Subject: Submittal Supporting Accelerated ABWR Review Schedule

Attached is the revised proposed closure of ABWR DFSER open item 17.3.5-1.

17.3 RELIABILITY ASSURANCE PROGRAM DURING DESIGN PHASE

ABWR Standard Plant

Figure 17.3-1. Typical GE-NE Organization for an ABWR Project

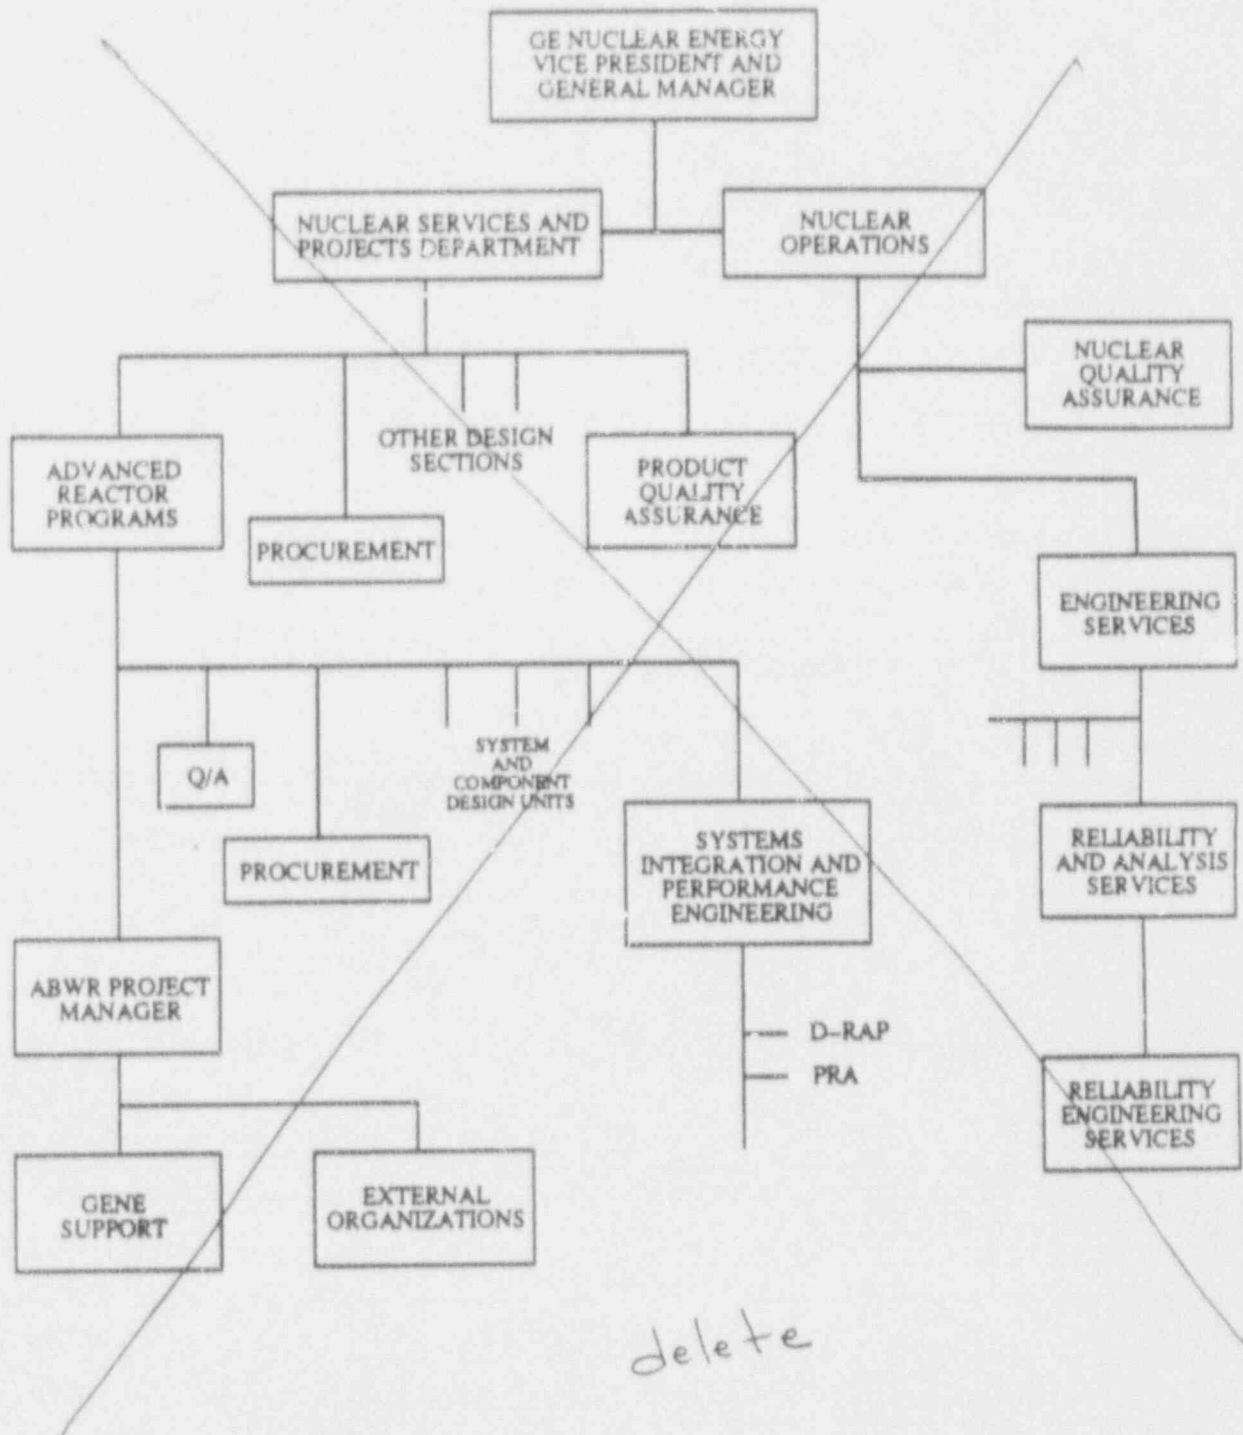
~~The relevant portion of the GE-NE organization chart for the ABWR D-RAP is shown in Figure 17.3.1. The~~
The D-RAP definition, reliability analyses, and the PRA, including Appendix 19K, ~~are~~ were performed by GE Nuclear Energy (GE-NE). 17.3.1

Complete the D-RAP and will
SSAR Appendix 19K, PRA Based Reliability and Maintenance, identifies certain risk-significant SSCs. The results of Appendix 19K can be used as a starting point for the D-RAP.
